Supplemental Site Characterization  
Investigation Work Plan  
Hudson Valley Regional Airport Site  
18 Griffith Way  
Town of Wappinger  
Dutchess County, New York  
NYSDEC Site # 314129

**REVISED SITE CHARACTERIZATION WORK PLAN  
HUDSON VALLEY REGIONAL AIRPORT SITE  
18 GRIFFITH WAY, TOWN OF WAPPINGER  
DUTCHESS COUNTY, NEW YORK**

Exhibit 2: NYSDEC Letter Providing Comments on the Draft Site  
Characterization Report Dated April 16, 2020

**FIGURE 1**  
**PROPOSED SURFACE WATER SAMPLING  
LOCATIONS**

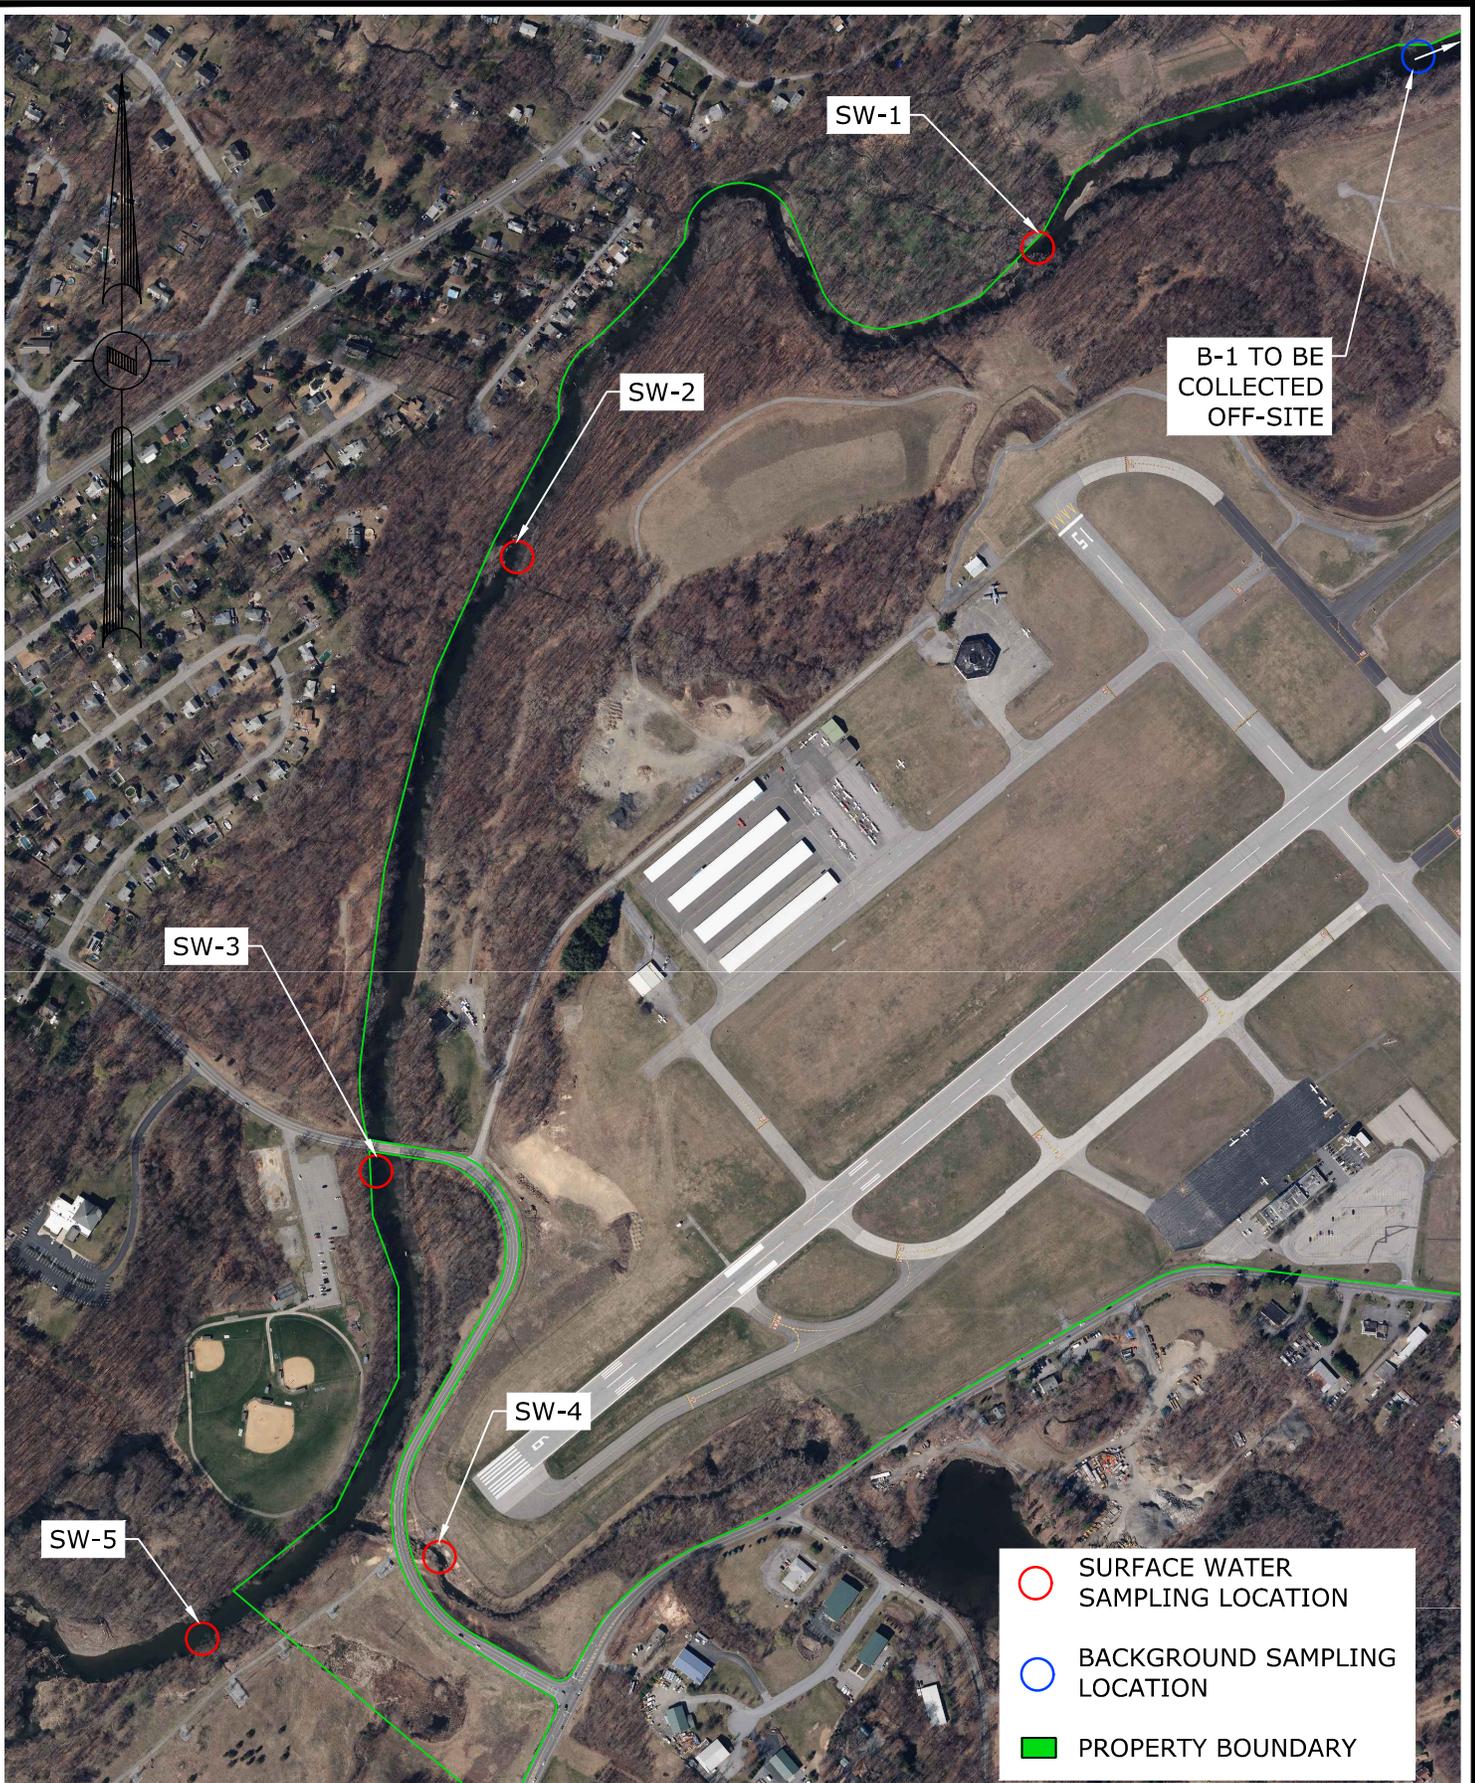
The surface water samples collected from the Wappingers Creek will be analyzed for PFAS and 1,4 Dioxane. We anticipate collecting six samples at the locations shown on Figure 1

**FIGURE 2**  
**PROPOSED OFF-SITE SAMPLING AREA**

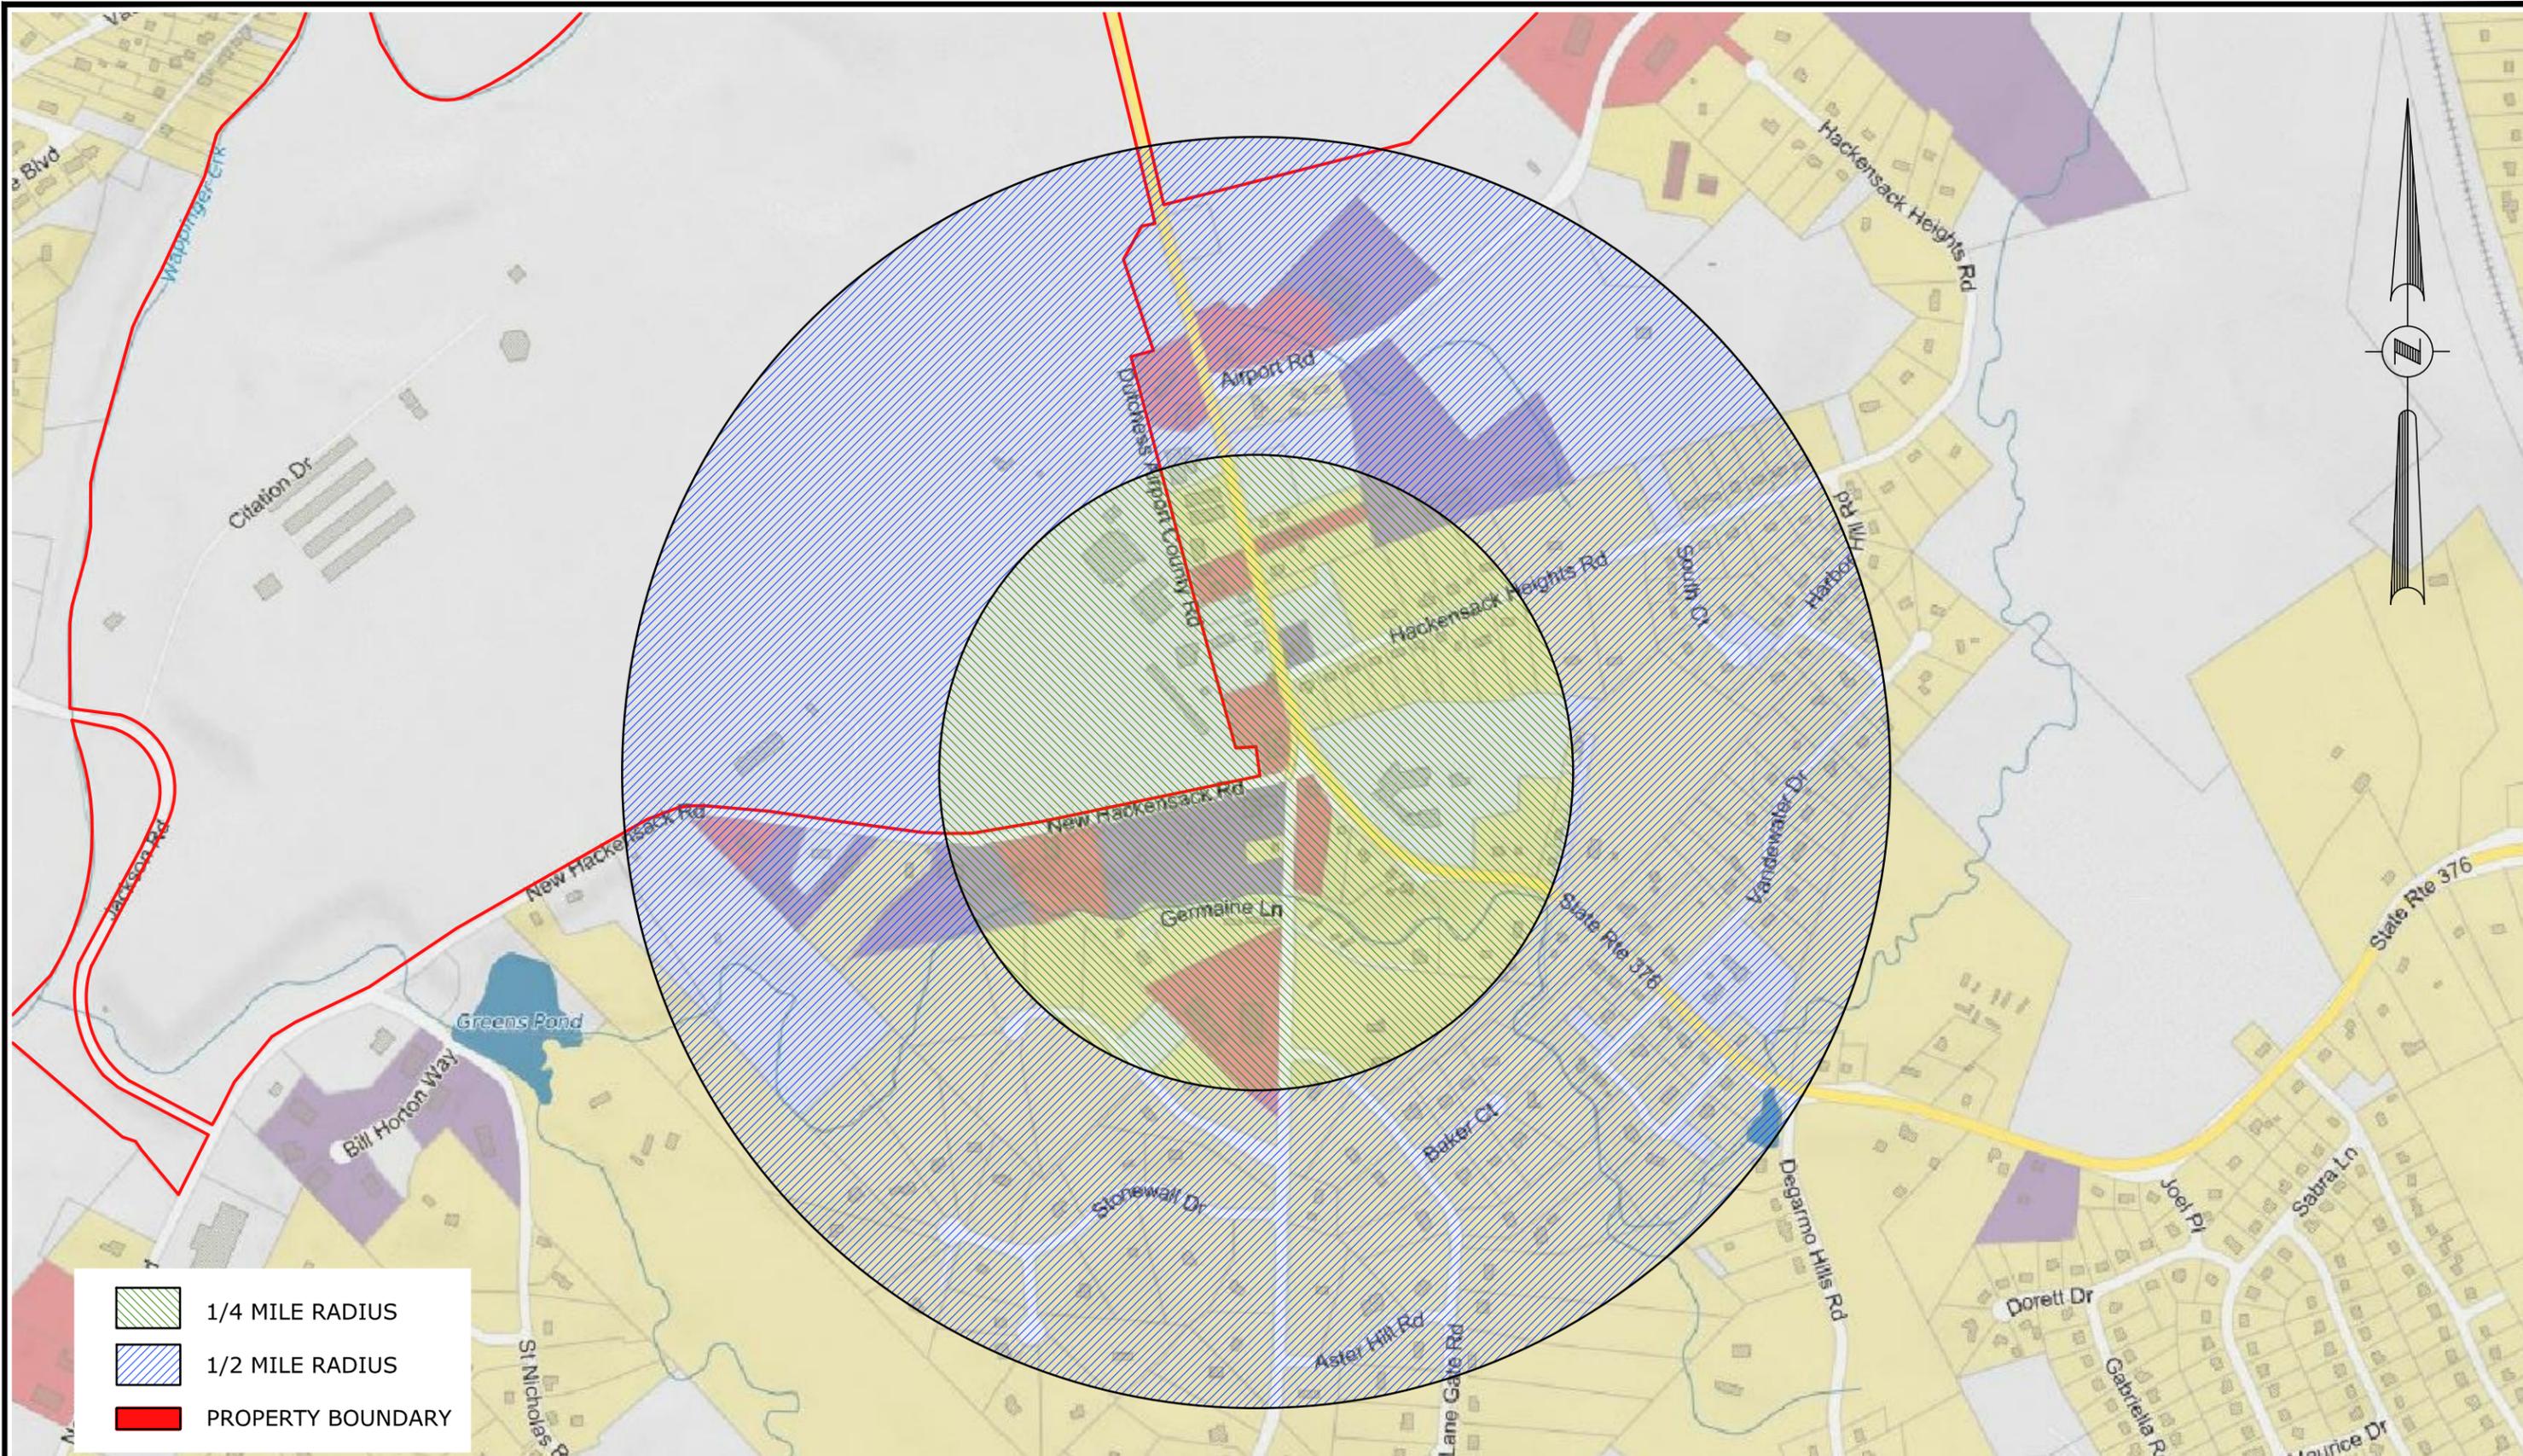
*Comment 12. Page 45, Section 6.3.3 Additional Discussion of PFAS Results: Based upon the results of on-site and off-site sampling, the Department is requesting additional sampling of off-site drinking water wells. A supplemental site characterization work plan to address further off-site sampling of drinking water wells should be prepared. The work plan should include identification of potential drinking water wells within a ¼ and ½ mile buffer from the boundary of the airport. At this time, the initial additional sampling should focus on the areas to the south*

*and east of the airport. Data indicate that one sampled property near the intersection of Route 376, New Hackensack Road, Lane Gate Road has total concentrations of PFOA and PFOS above the EPA's Health Advisory Level of 70 ppt. These detections require some form of mitigation consistent with the Order as noted above. The County should provide a separate work plan and schedule to provide and/or ensure a supply of potable water to the affected property. Bottled water must be provided to the affected property immediately and until a long-term solution is implemented. A POET system is the recommended and preferred option, as indicated in the consent order, absent a public water supply connection.*

Response: The County agrees to sample some additional off-site drinking water wells. There are approximately sixty (60) potential sampling locations within the ¼ to ½ mile radius. The County proposes to sample the private water supply wells progressively, starting with the homes and businesses immediately adjacent to the airport boundaries in the first round of sampling and extending away from the airport in subsequent rounds until PFAS is not detected or the ½ mile radius is reached. The County will only extend further away from the initial ¼ mile boundary if the data indicates that these initially sampled wells are impacted by PFAS compounds.

If a property is affected by PFAS compounds above the USEPA's 70 ppt health advisory, that property will be provided with bottled water and a POET system. The process for addressing impacted drinking water wells above the USEPA health advisory levels is described in a separate work plan provided under separate cover. The New York State Department of Health has proposed a drinking water Maximum Contaminant Level (MCL) of 10 ppt for PFOA and 10 ppt for PFOS. If the proposed MCL is adopted, the Department will request the County begin offering bottled water to, and POET installation at, those affected properties above 10 ppt for PFOA or PFOS in the manner described in this work plan. If the proposed MCL is adopted, the County will work with the Department to renegotiate the Consent Order.
